City Planning Commission Meeting – May 26, 2015

CONSIDERATION – SUBDIVISION DOCKET – 043-15

Applicant: Morning Star Baptist Church

Proposal: Subdivision of Lots 1, 1-A, A-1, 1, 2, 3, 4 & 5 into Lot 5-A

A Resubdivision of Lots 1, 1-A, A-1, 1, 2, 3, 4, & 5 into Lot 5-A.

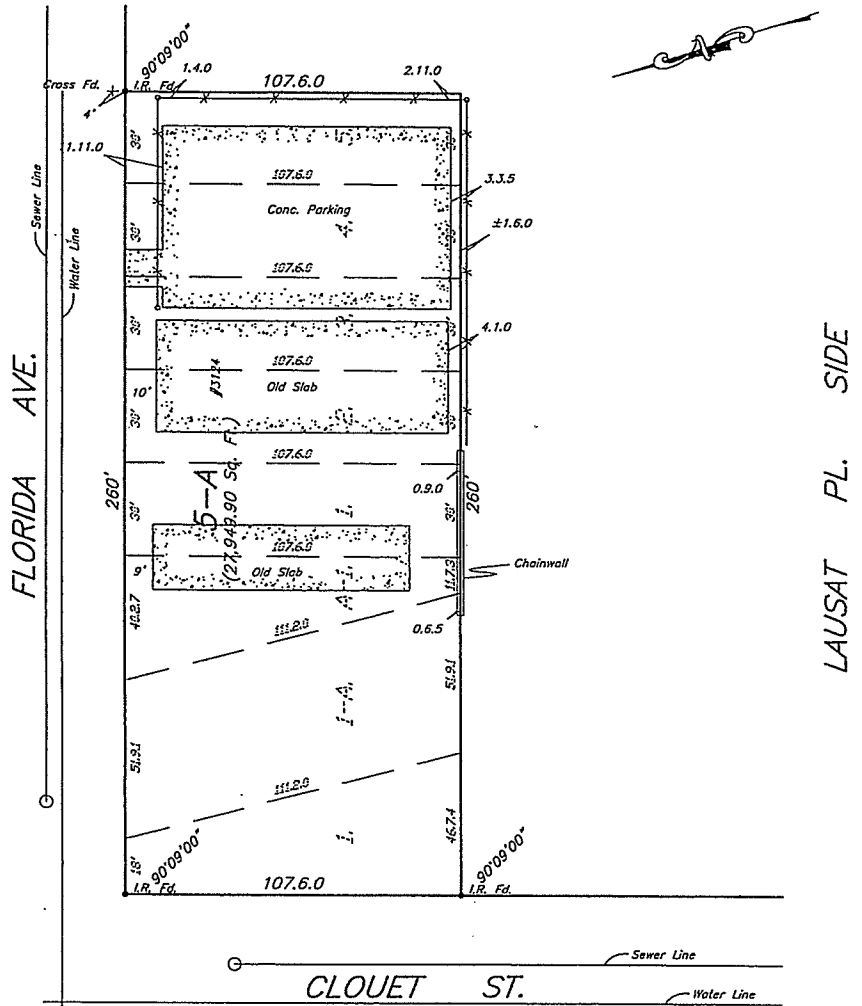
The proposed lot does not meet criteria a, b or c as it would create each of the situations listed above. According to an aerial view of the site through the City of New Orleans' online property viewer, there are instances of some existing lots which would have similar frontages on Clouet St.; however, these lots do not represent 50% of the existing lots within 500' of the petitioned site. The proposal would create a single lot of record, which would cause the entire development to have frontage on Clouet St., which is not a major street shown on the Major Street Plan. Therefore, the proposal does not meet the criteria of **Article 5, Section 5.1.8 – Reversal of Lot Frontage** of the *Subdivision Regulations* and the staff does not support it.

1. The proposed subdivision does not meet the criteria under **Article 5, Section 5.1.8 *Reversal of Lot Frontage*** of the *Subdivision Regulations*. The proposed subdivision could allow a required side yard opposite from a required front yard, in addition to a required rear yard opposite a required side yard and a required front yard opposite a required side yard. If the church was constructed in this manner, the development may not fit in with the development character of the surrounding area.

The staff recommends **DENIAL** of Subdivision Docket 043-15.
